AERONAUTICAL CHARTING FORUM
Instrument Procedures Group
October 27, 2009
HISTORY RECORD

FAA Control # 09-02-289

Subject: Use of Leg Combinations and Altitude Constraints on RNAV Departure Procedures.

RUUDY ONE DEPARTURE (RNAV)

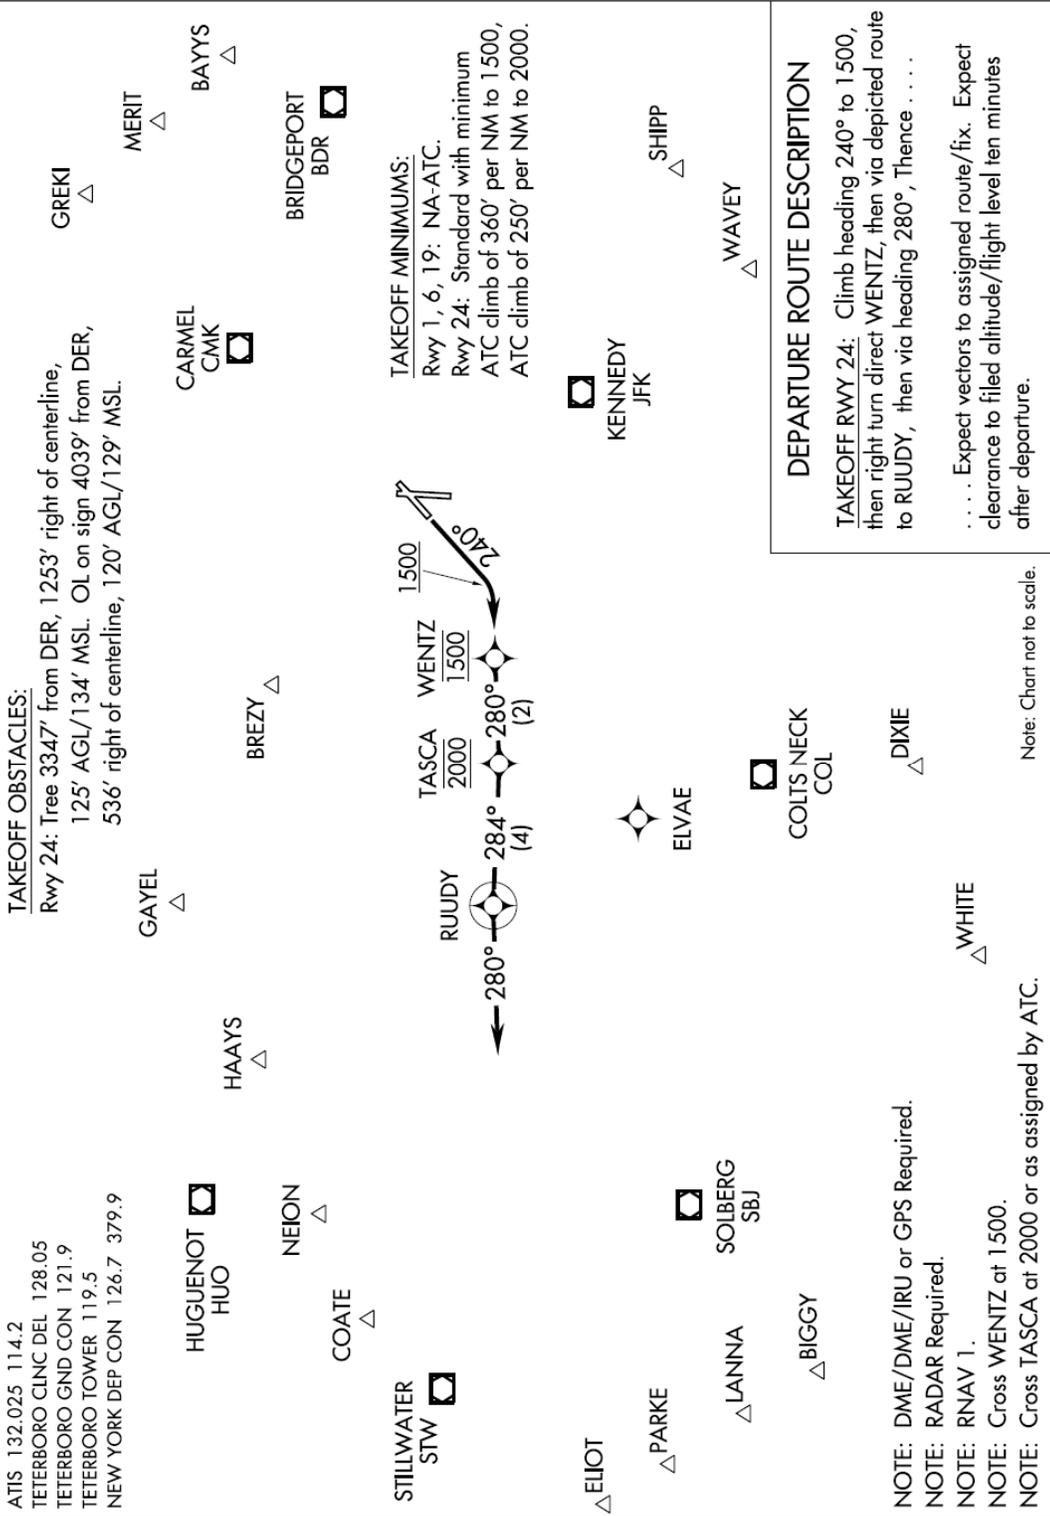
1. The initial departure routing of the original RUUDY ONE RNAV SID at Teterboro, NJ (TEB) – (see attachment) used a heading to altitude (VA) leg followed by direct-to fix (DF) leg. However, the VA altitude constraint (at or above 1500 ft) was also followed by a hard (at) altitude constraint of 1500 ft at WENTZ.

While a few autoflight systems (with climb-capable VNAV) were able to manage this sequence of altitude constraints, many others experienced leg-sequencing issues due to the need to level at 1500 ft on the departure route to WENTZ. These leg-sequencing issues resulted in wide variations in the geographic location where the aircraft initiated the right turn direct to WENTZ.

Due to the procedure's close proximity to the Newark, NJ airport, numerous ATC interventions were required to manually initiate the turn before traffic separation was affected. As result, this procedure was withdrawn from use after approximately 48 hours.

DUUKE ONE DEPARTURE (RNAV)

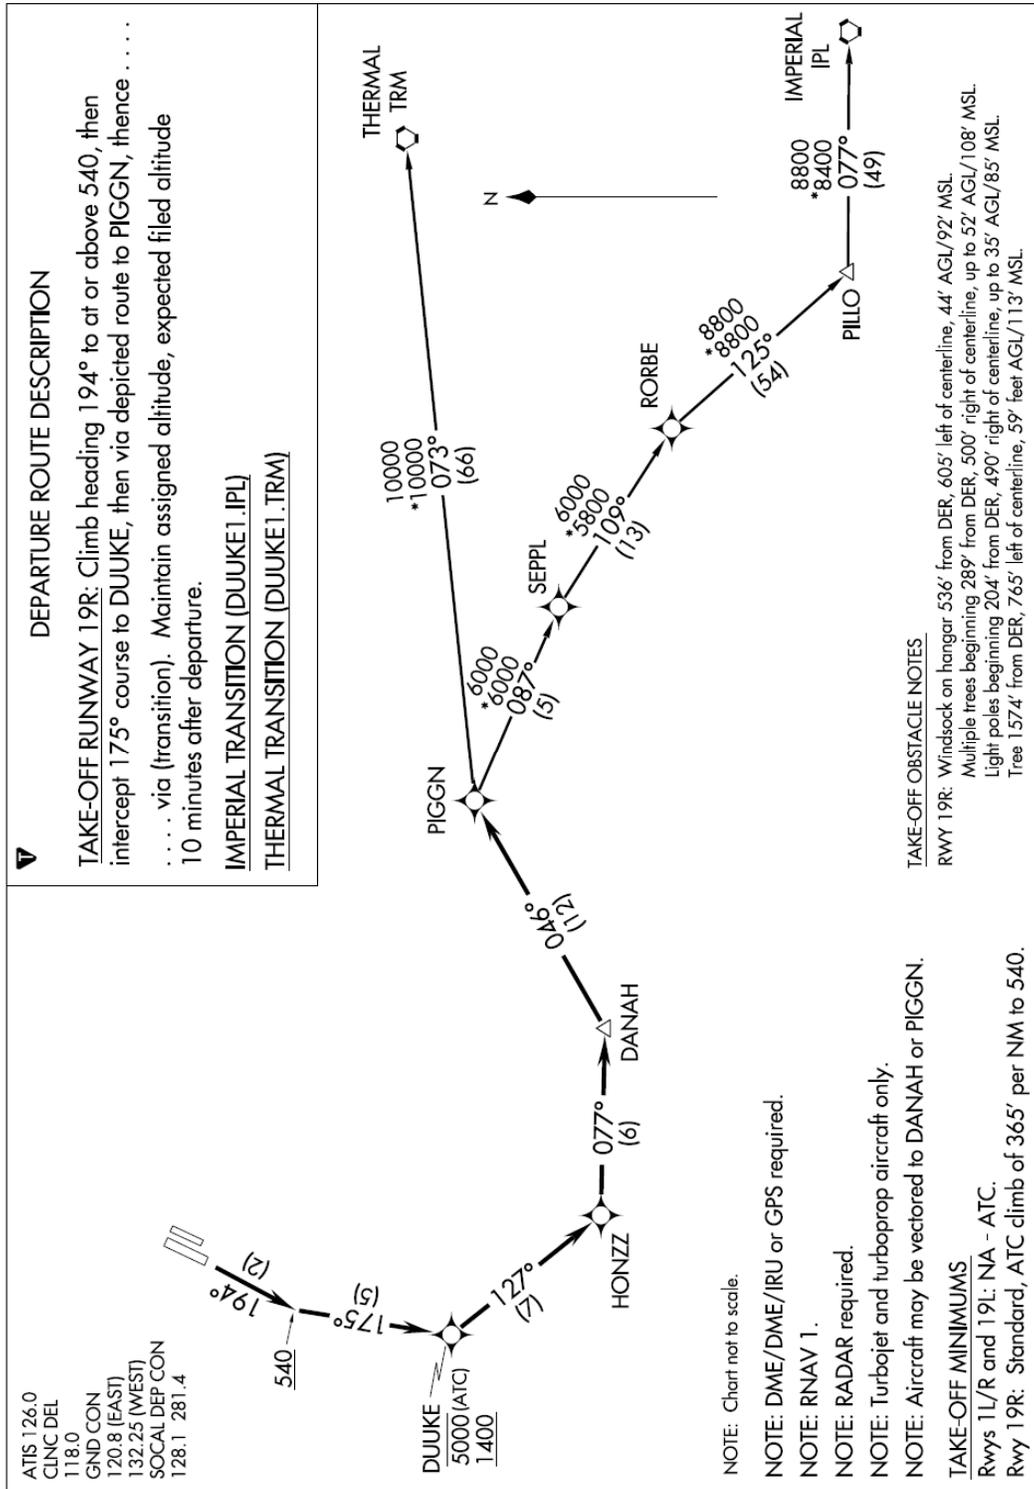
2. The initial departure route of the DUUKE ONE RNAV SID at Santa Ana, CA (SBA) – (see attachment) employs a heading to course intercept (VI) leg followed by a course to fix (CF) leg terminating at the DUUKE waypoint. The initial departure route instruction is to "climb heading 194 (runway heading) to **at or above 540**, then intercept the 175 course to DUUKE". A 540 ft "AT or ABOVE" altitude constraint is located by FAA source at the VI-CF intercept point and is designated on the chart.

The charting of the 540 ft "at or above" altitude constraint can be a source of confusion for pilots who are accustomed to initiating a leg change when an "at or above" note is published on a chart. The instruction "fly xxx to at or above" is often associated with a heading-to-altitude (VA) procedure leg. However, in this case, the altitude restriction is being used on a VI to CF leg combination.

Pilots of high performance aircraft will frequently climb above the published constraint (in this case 540 ft) well prior to reaching the intersection of a VI-CF leg combination. As a result, pilots may be tempted to manually initiate a course change and proceed direct to the terminator fix defined by the CF leg. The SNA ATCT

issued a severely flawed Letter to Airman (attached) admonishing against manual intervention and advising pilots to fly the procedure as published.

1. Prohibit the use the VA-CF leg combination.
2. Remove the option to specify an altitude restriction on a VI-CF leg combination. When necessary, designate a mandatory climb gradient to establish a minimum crossing altitude at the VI-CF intercept point. This climb gradient must **not** be annotated (ATC).
3. When a VA-DF leg combination is necessary, require that the VA climb-to altitude used be designated as an “**at or above**” altitude. Require any altitude constraint at the subsequent DF termination fix to be higher than the VA altitude constraint. It is recommended that any altitude constraint at the DF terminus fix be at least 500 ft above the VA altitude constraint. If this is not possible, the suitability of an alternative VI-CF leg combination should be examined.
